NOTICE OF DECISION

DECISION OF THE PLANNING COMMISSION

**CLASS 3 DESIGN REVIEW / CLASS 3 SITE PLAN REVIEW / CLASS 2
ADJUSTMENT CASE NO.: DR-SPR-ADJ19-10**

SUMMARY: Proposed three story mixed-use multi-family and retail development on a vacant portion of the site, and maintaining an existing parking lot and driveways.

ARCHITECTURAL
SITE PLAN

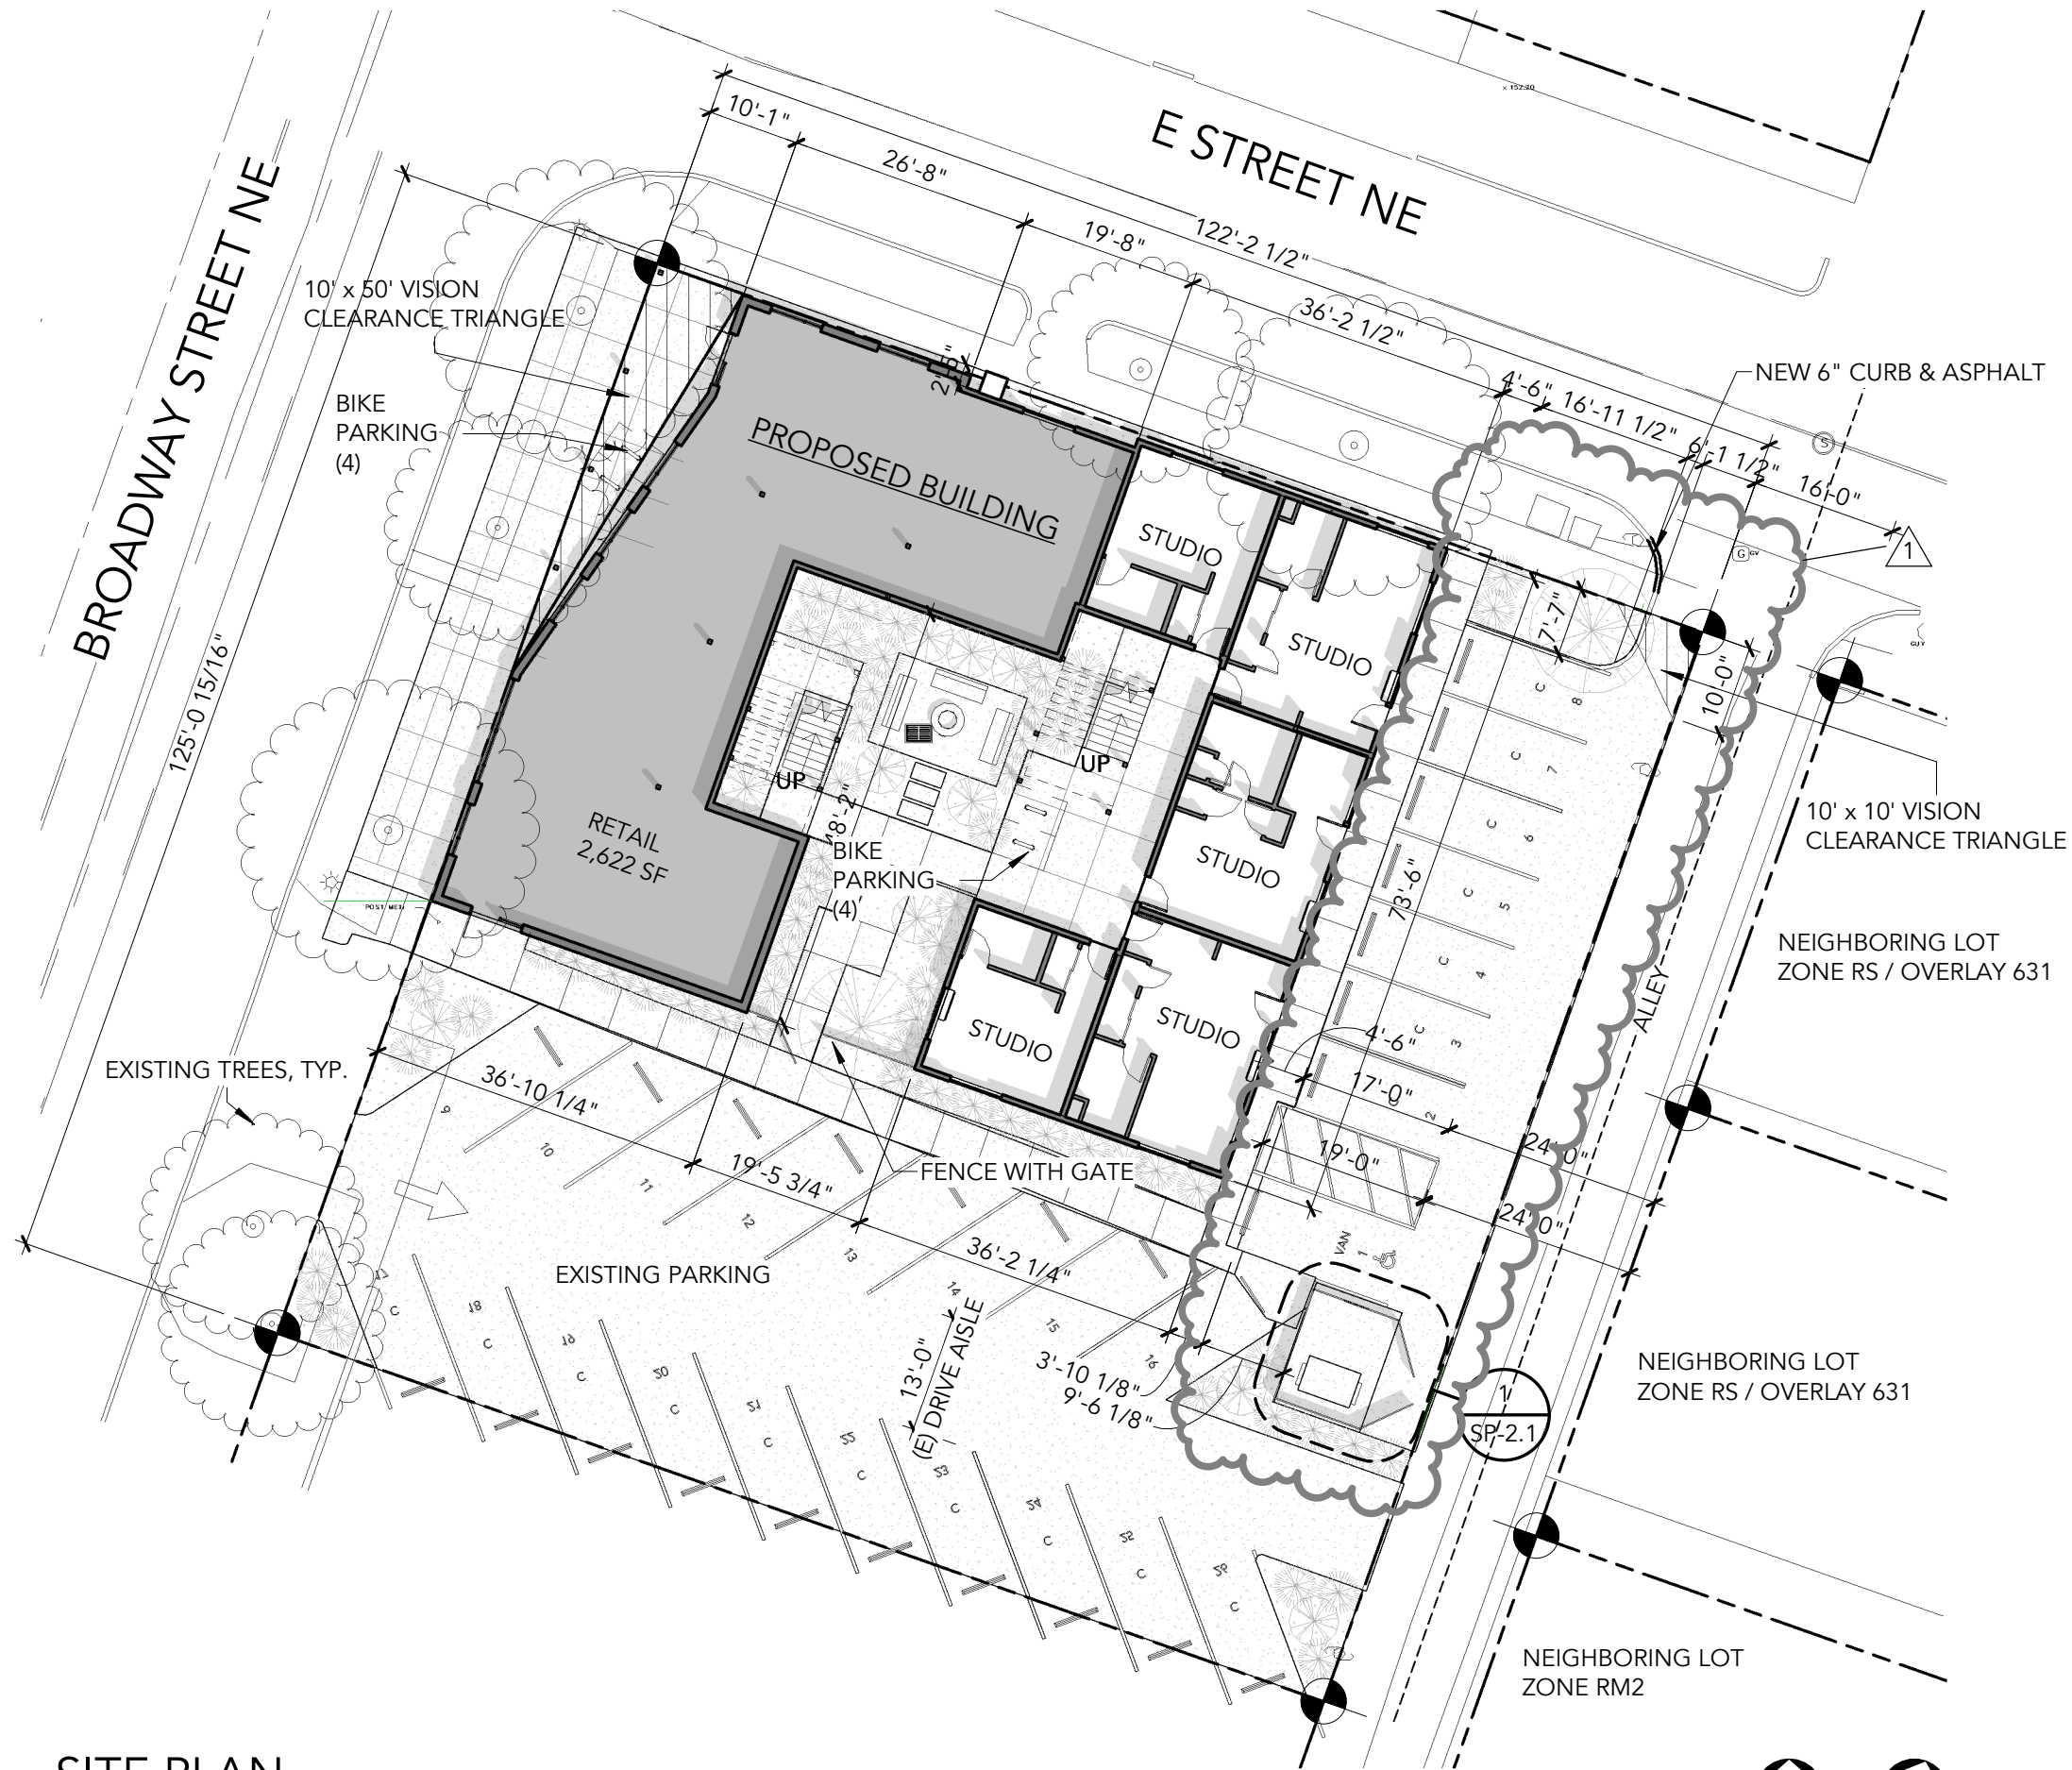
The proposed plan shows awnings encroaching into the right-of-way. The applicant shall obtain awning permits.

The proposed plan also shows bicycle parking spaces within the vision clearance triangle. The bicycle parking shall comply with SRC Chapter 805.

The existing alley approach along E Street does not meet PWDS. Pursuant to SRC 803.040, the applicant shall be required to replace the existing alley approach along E Street NE pursuant to PWDS.

Condition 2: Obtain awning permits for proposed awnings encroaching into the right-of-way.

Condition 3: Proposed bicycle parking within the vision clearance triangle shall comply with SRC Chapter 805.

Condition 4: Replace the existing alley approach along E Street NE pursuant to Public Works Design Standards.

1 TRASH ENCLOSURE
SCALE: 1/4" = 1'-0"

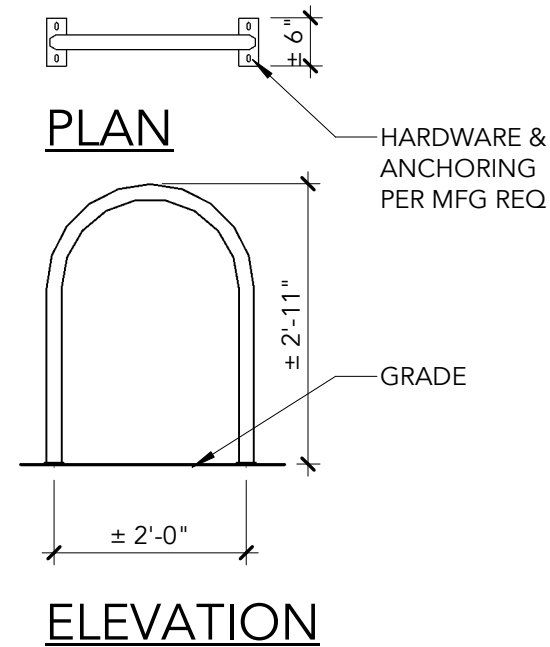
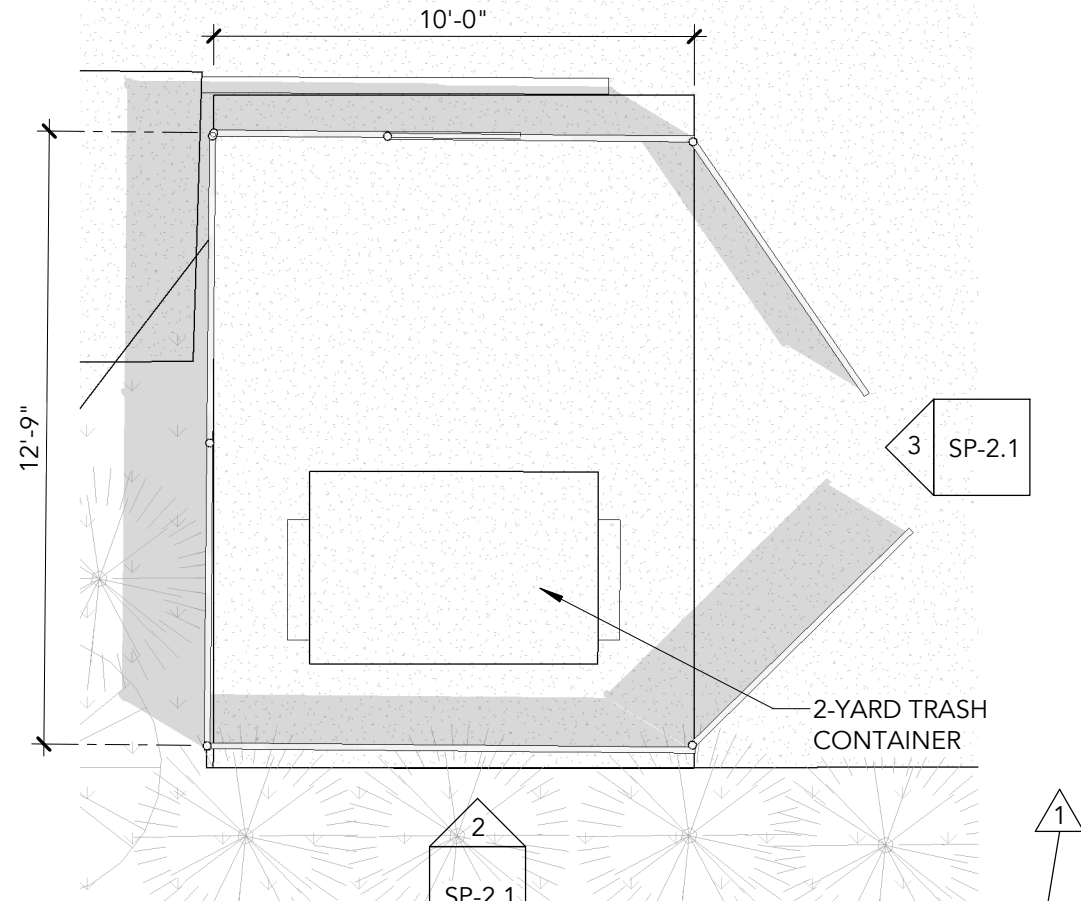
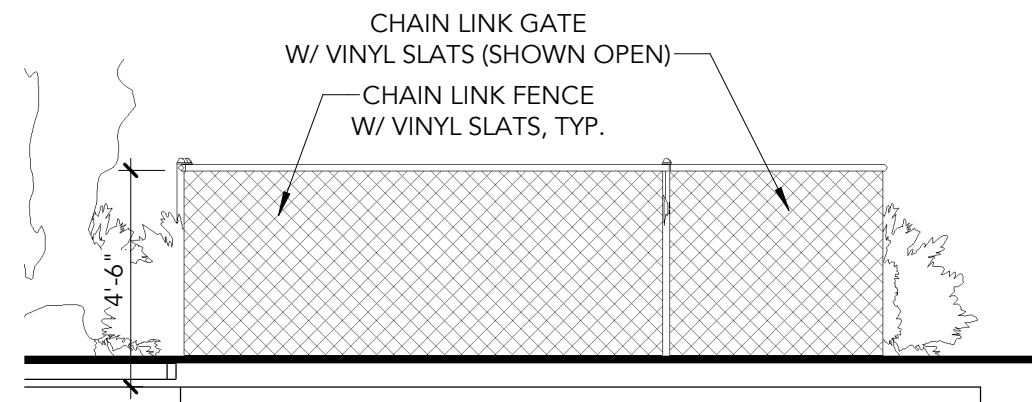
Finding: The proposed site plan indicates that the enclosure walls will be chainlink with privacy slats. A bumper curb 12 inches inside the perimeter of the enclosure walls is required, however the curb is not indicated on the proposed plans.

Condition 1: Development of the solid waste service area shall conform to all applicable standards of SRC Chapter 800.

LANDSCAPE PLAN

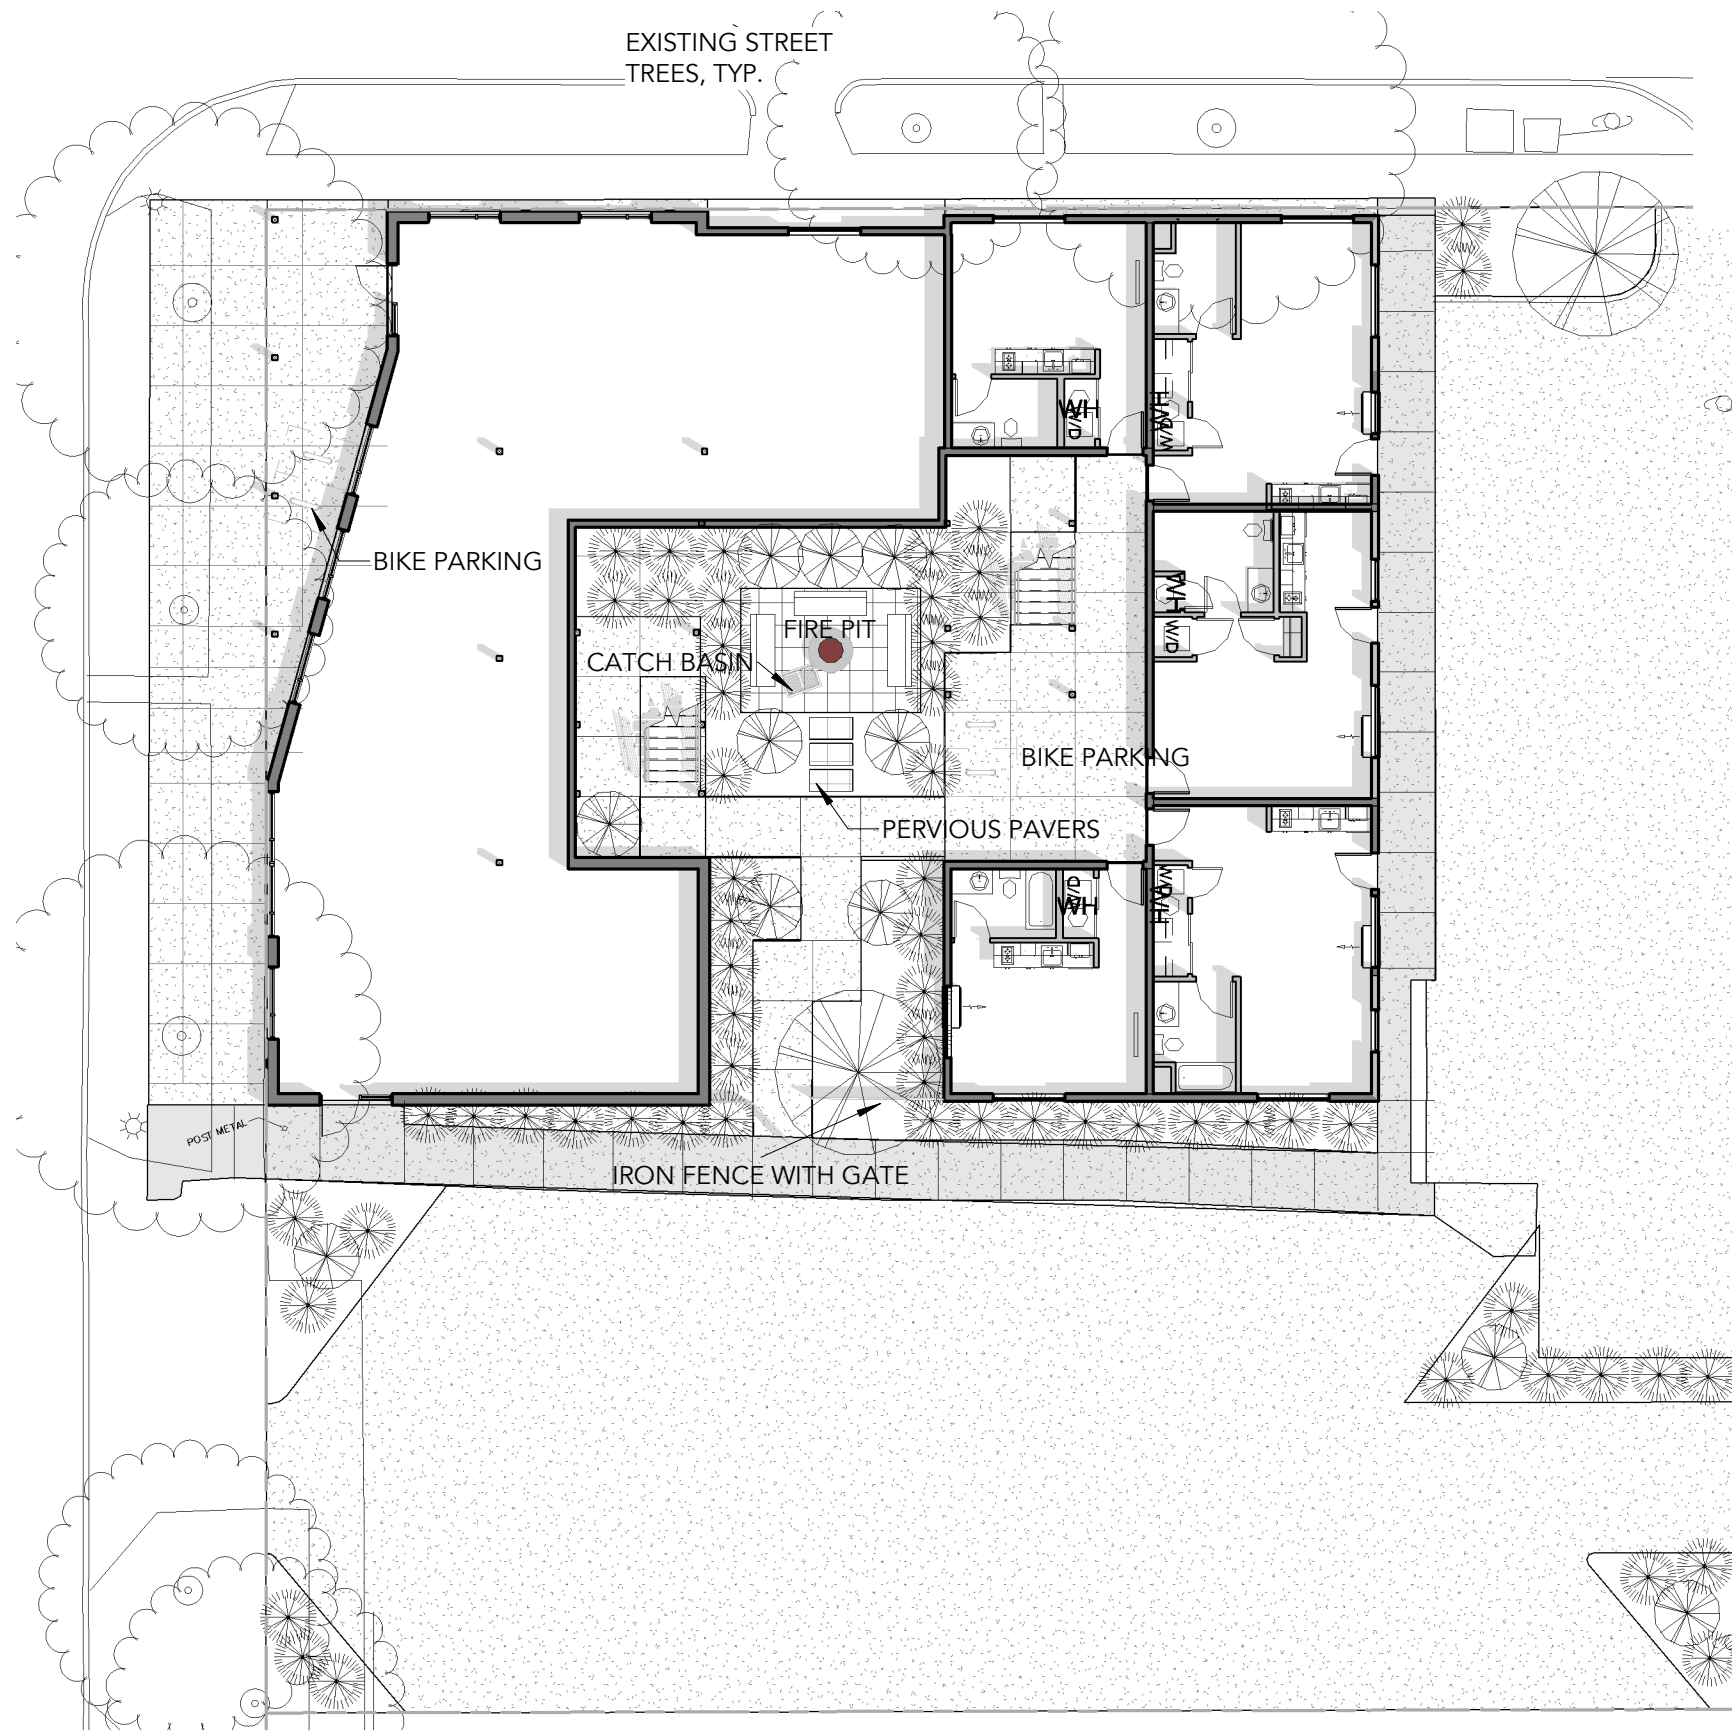
Finding: The proposed site plan indicates that approximately 1,774 square feet of landscaping is provided for the development site. However, as conditioned a minimum of 115 plant units are required for the proposed development. Of the required plant units, a minimum of 46 plant units shall be a combination of mature trees, shade tree, evergreen/conifer trees, or ornamental trees ($115 \times 0.4 = 46$).

Condition 8: A minimum of 115 plant units shall be incorporated into the landscape design.
